*BEACON PLANNING BOARD*  
*Via Video Conference*  
*BEACON, NEW YORK 12508*  
*Phone (845) 838-5002 Fax (845) 838-5026*

The Planning Board will meet on **Tuesday, April 14, 2020** in the Municipal Center Courtroom. Due to public health and safety concerns related to COVID-19, the Planning Board will not be meeting in-person. In accordance with the Governor's Executive Order 202.1, the April 14, 2020 meeting will be held starting at 7:00 PM via videoconferencing, and a transcript will be provided at a later date. The public can watch the live meeting online at YouTube at [www.youtube.com/channel/UCvPpigGwZdeR7WYmw-SuDxg](http://www.youtube.com/channel/UCvPpigGwZdeR7WYmw-SuDxg). If any interested members of the public would like to provide comments on the application, comments can be called in during the meeting at (929) 205-6099. Webinar ID: 254 824 895 Comments can also be provided via email no later than 5PM on April 14, 2020 to Etha Grogan, Planning Board Secretary, at [egrogan@cityofbeacon.org](mailto:egrogan@cityofbeacon.org). Please check the meeting Agenda posted on the City website ([www.cityofbeacon.org](http://www.cityofbeacon.org)) for further instructions to access the

Designed	Checked
CL	CL
Date: 09/10/20	Scale: 1" = 30'
Project No.: 81750.00	Sheet No.: 3 of 10
<b>C130</b>

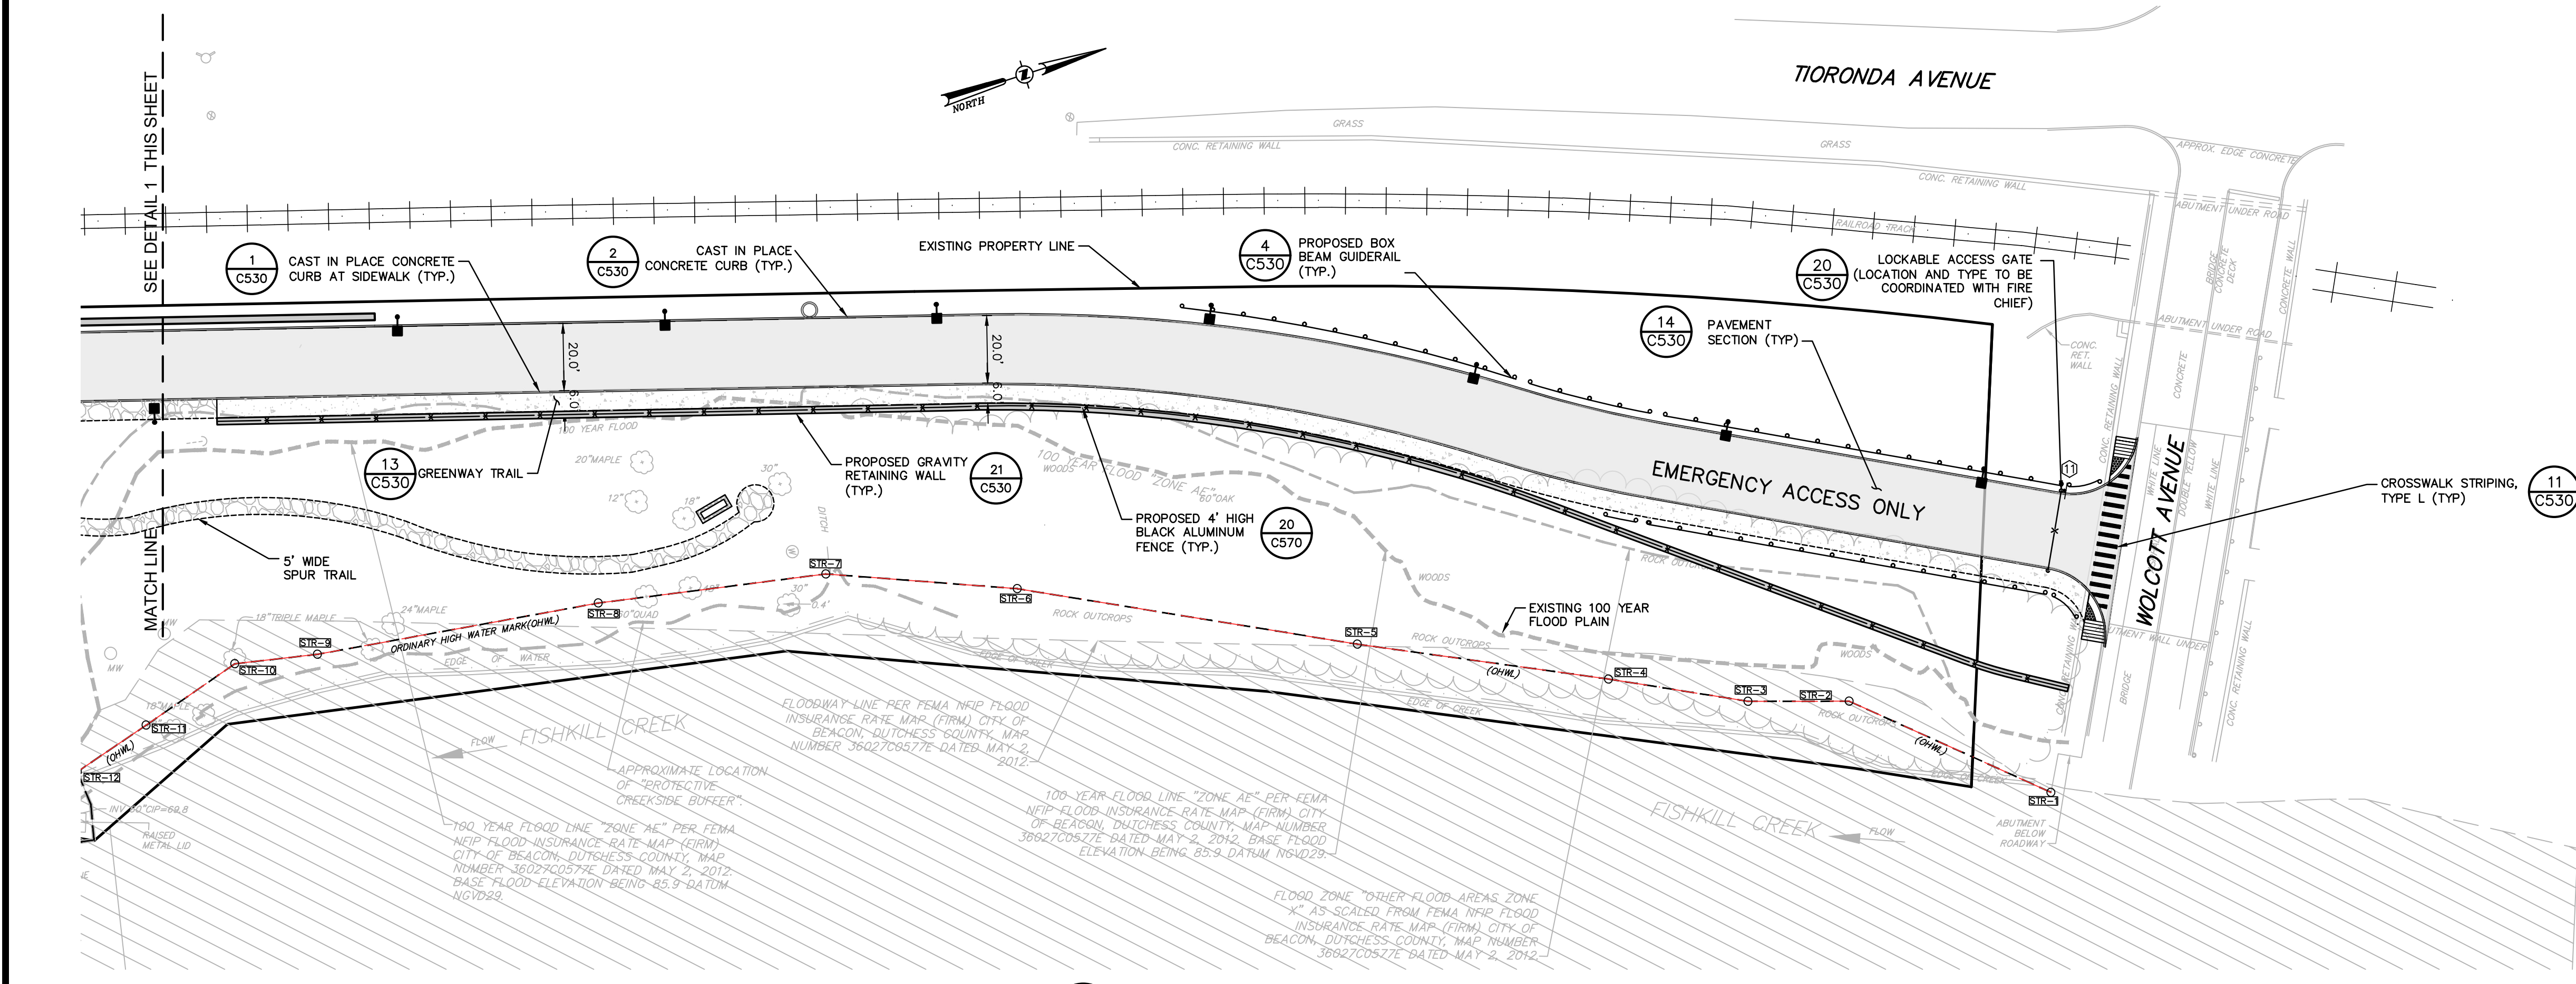
1. For the Site Plan Sheet C130:
  - a. The proposed sidewalk along the upper parking area should be extended north to connect to the Building 200 entrance or at least the primarily pedestrian-oriented driveway in front of Building 200. If grading is an issue in this area, the intervening spaces closest to Building 200 could be relocated to across the parking aisle and/or near the refuse enclosure.

- b. The detail for the upper ADA trail section is 26, not 19.
  - c. The ramp near the refuse enclosure should have a handrail detail.
2. In response to the Greenway Trail Committee comments:

- c. The Trail Committee requested that typical 8-foot through trail width be maintained at the stairs, but the plan narrows the trail at the three stair sections between buildings 100 and 200.

3. On Sheet C530 the trail surface on Site Detail 22 or 25 should be noted as ADA-compliant.
4. The location of a second bike rack should be shown on the Site Plan near Building 100.

JOB #: 2019-021  
 DATE: 10/29/19  
 SCALE: 1" = 20'  
 TITLE: SP-1  
 SHEET: 3 OF 6

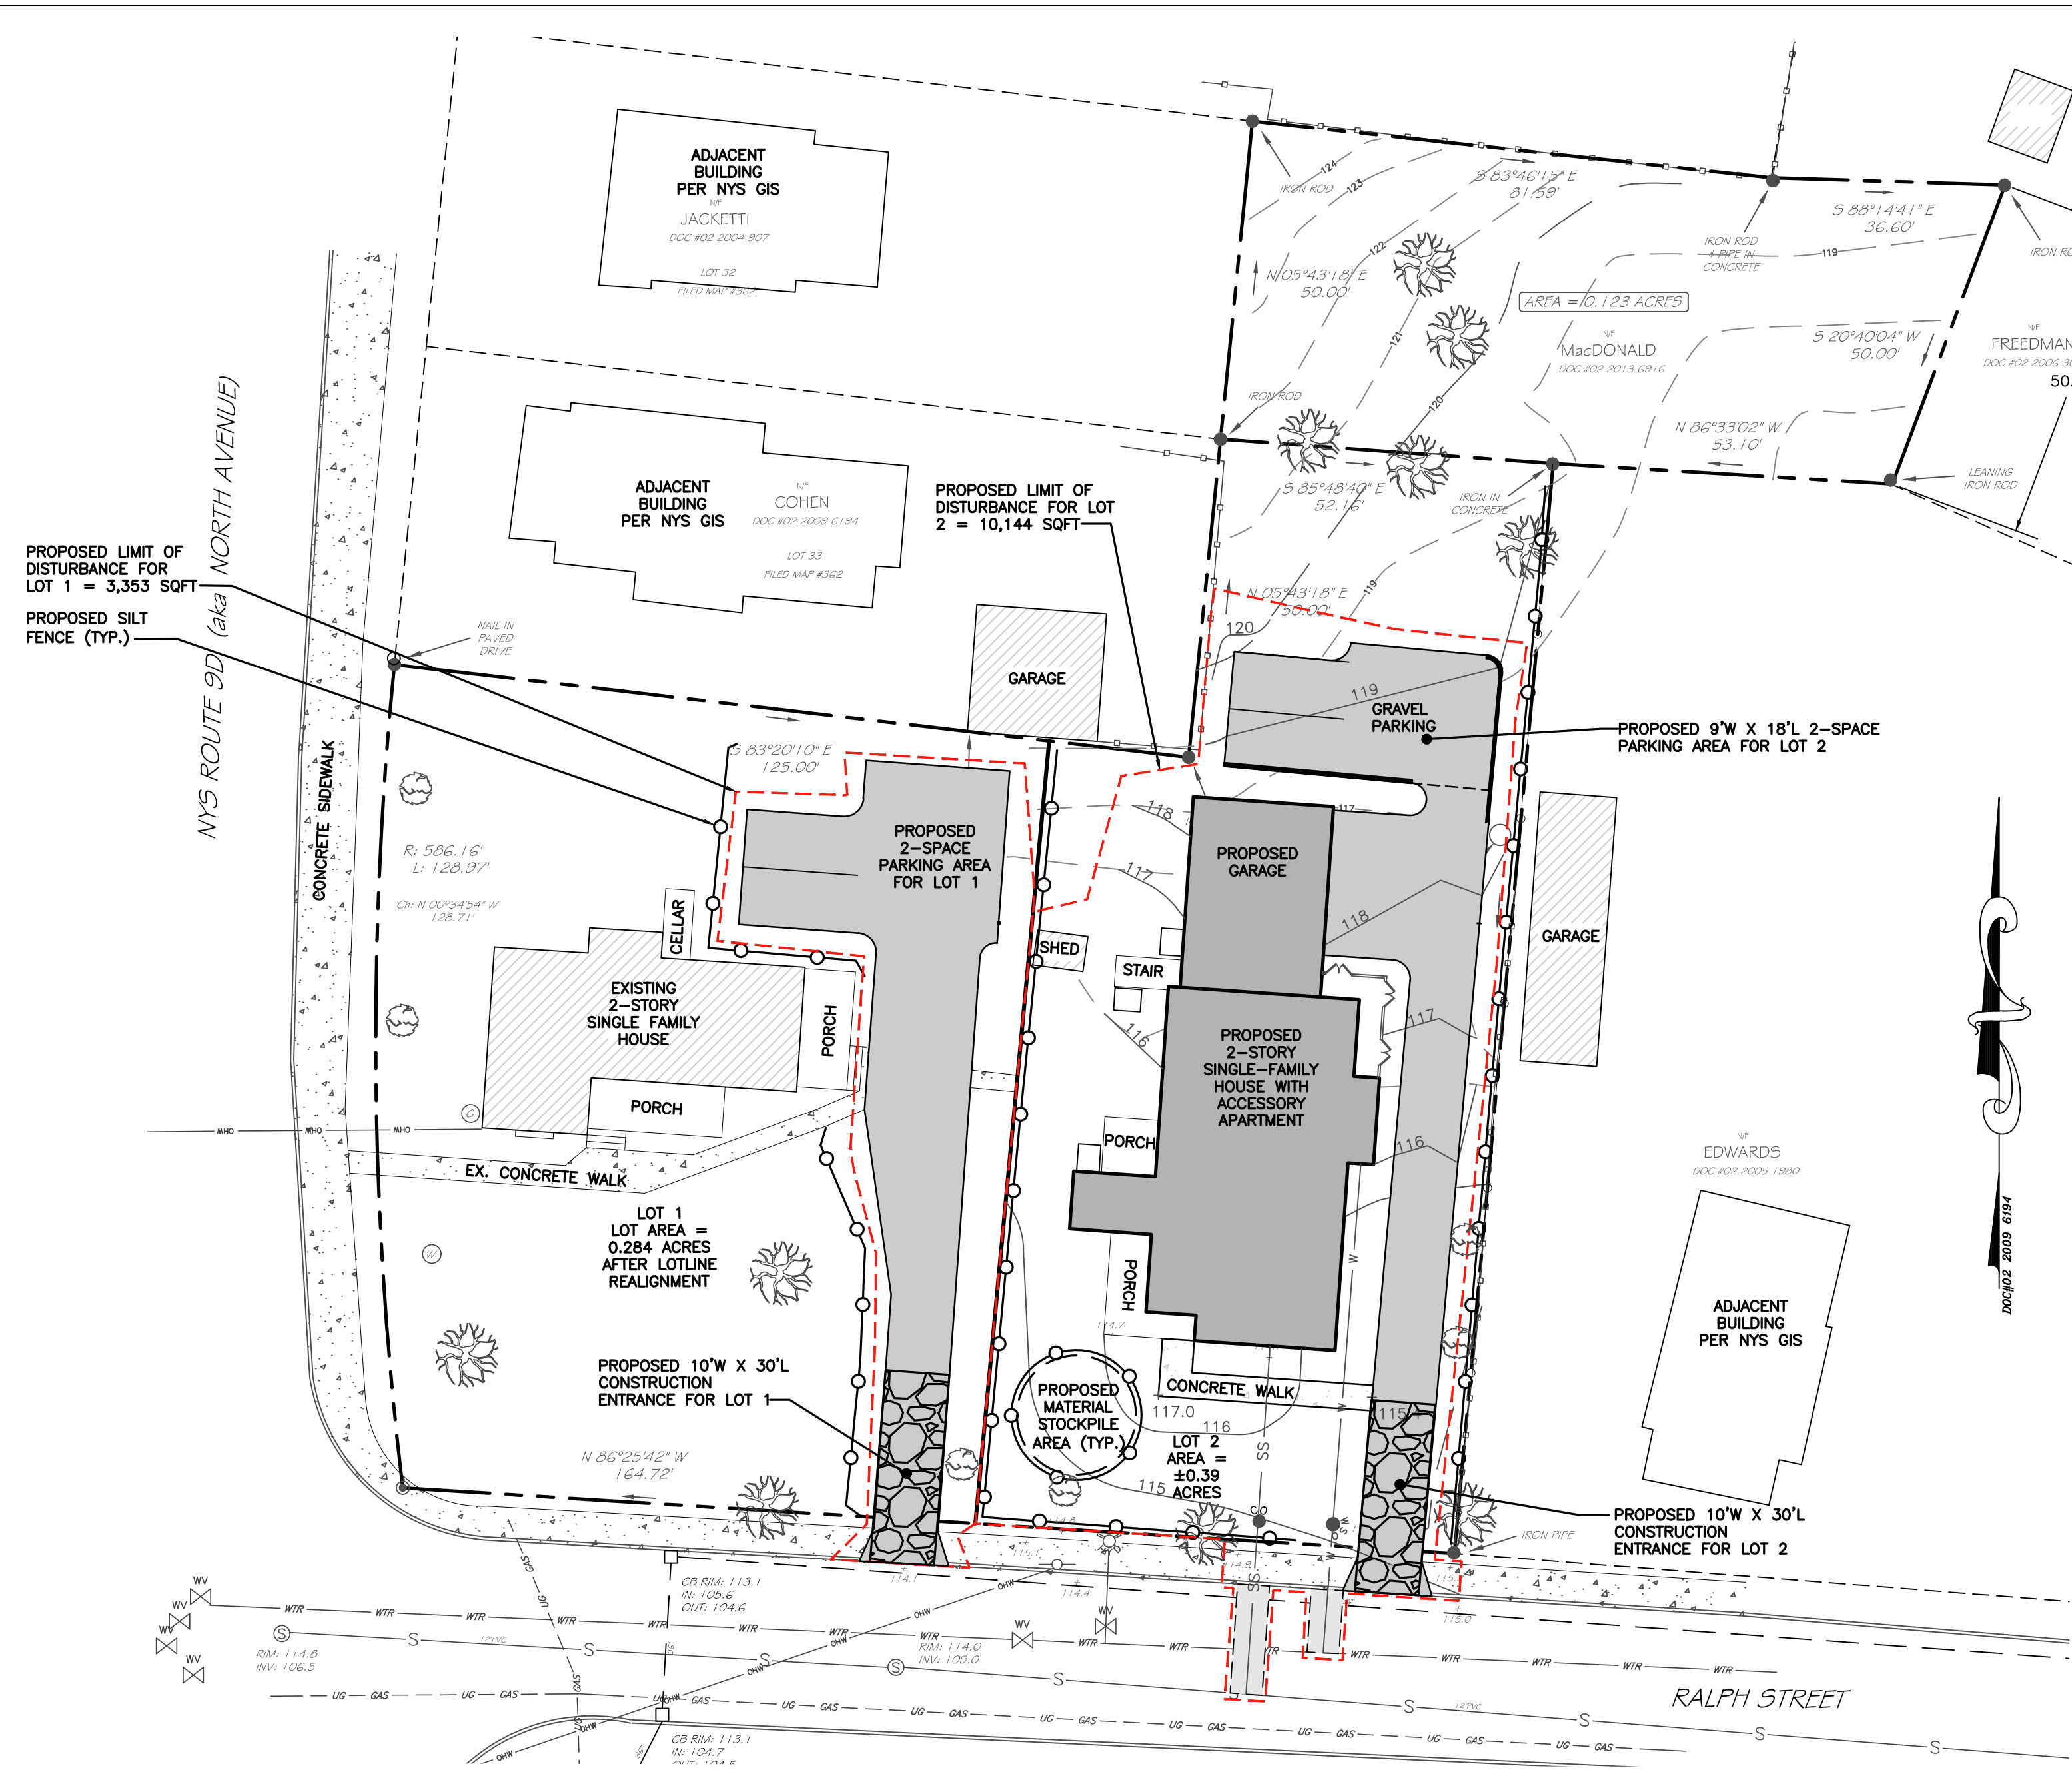
2. For Sheets SP-1 and GU-1, the fence for the refuse containers should be completely shown on the plans.
3. The accessory apartment appears to meet all the standards in Section 223-24.1, but it requires a Special Permit from the City Council. The Planning Board should submit a recommendations report to the Council.

**JOB #:** 2019-021  
**DATE:** 10/29/19  
**SCALE:** AS SHOWN  
**TITLE:** CD-1  
**SHEET:** 5 OF 6

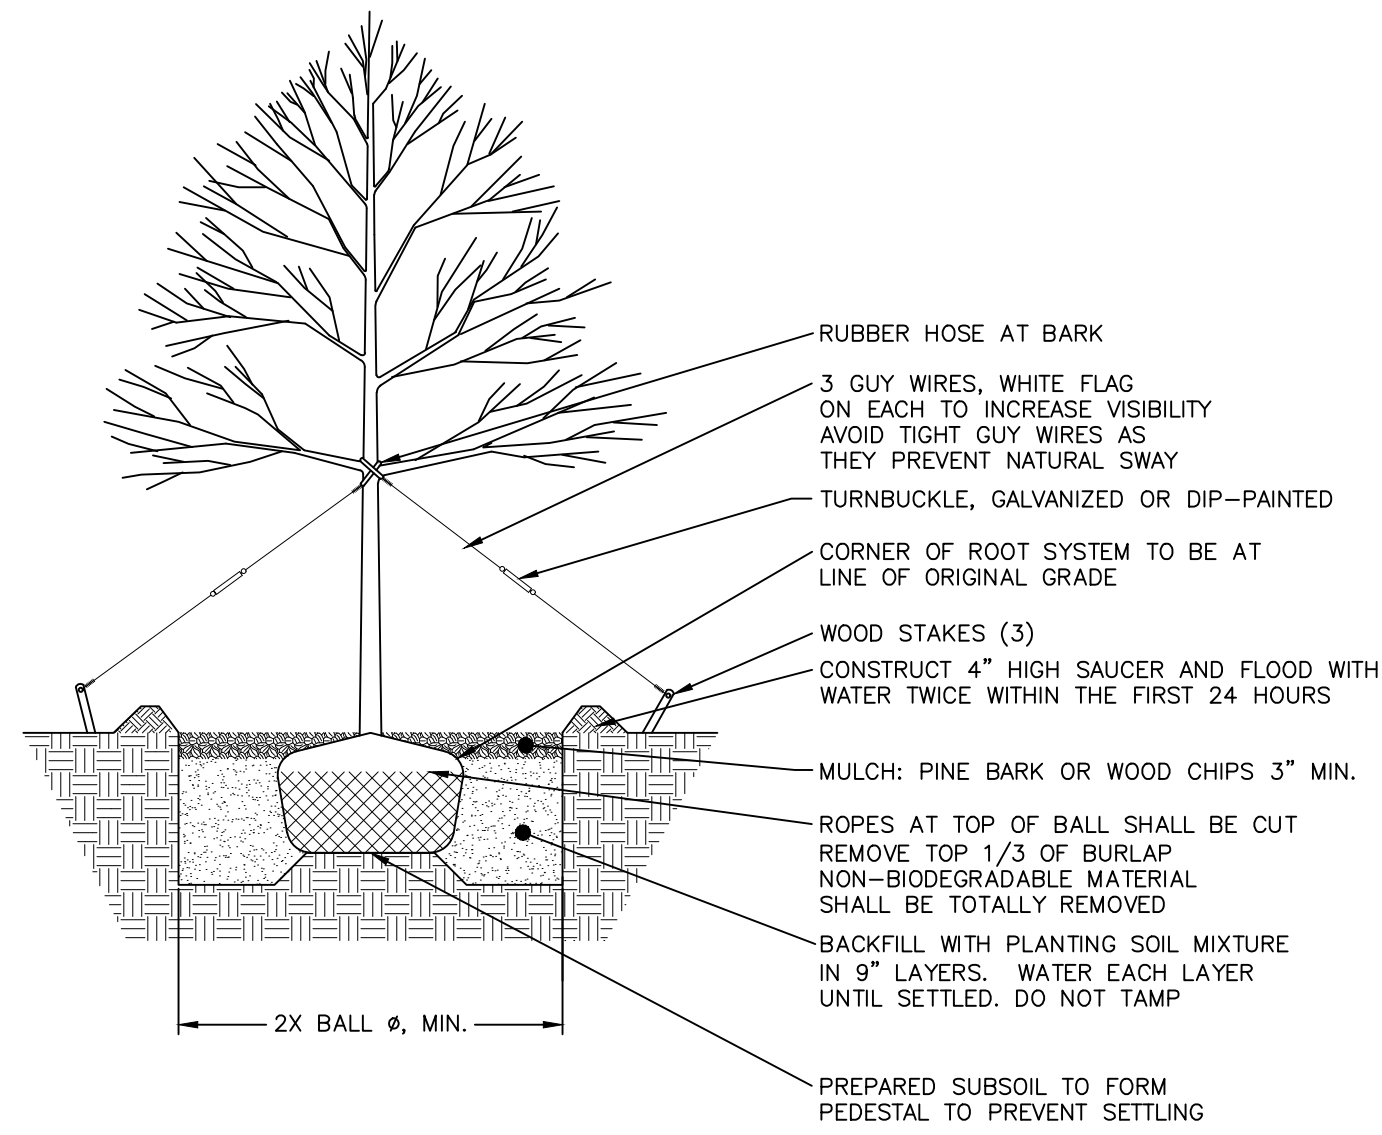
1. The project information table has been revised to show the subject parcel is 0.33 acre.
2. Sheet CD-1 has a wood stockade fence detail.
3. The driveway provides for two parking spaces, with an area for either car to back into in order to drive forward out of the driveway. We believe that the configuration works and would not like to add more impervious area to the driveway.
